**From:** "Vickie" <vickie.allen@imssystemsinco.com>  
**To:** "Bill Ward" <wrw1@nrc.gov>  
**Date:** Fri, Oct 6, 2000 9:48 AM  
**Subject:** Fw: NRC / Nucor C98-22-007

Subject: NRC / Nucor C98-22-007

**Spiralfeder 0021-071-01**

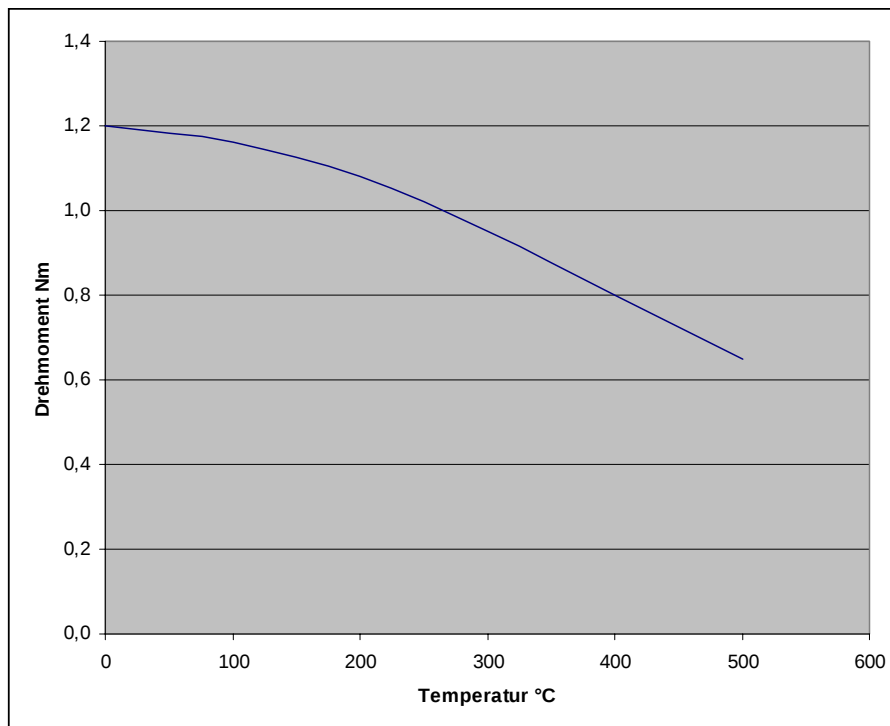
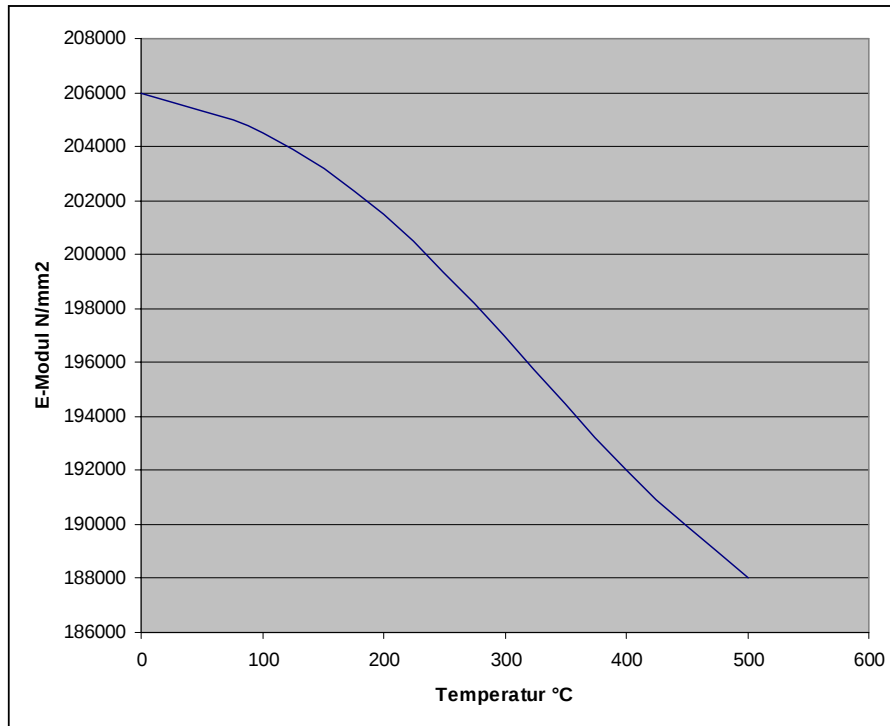
Enclosed is the final question that you have requested. If you need any thing further please call.

I hope that is the answer of ther question.

>  
>  
>  
>  
> Christoph Hollands@IMS  
> 06.10.2000 17:26  
>  
> Hey Vickie,  
>  
> ca. / max 0.7 Nm it dependent a littlebit of the bearings age.  
>  
> I hope realy that was the last question !  
>  
>  
> Mit freundlichen Grüßen  
> Christoph Hollands  
> IMS GmbH  
>  
>  
>
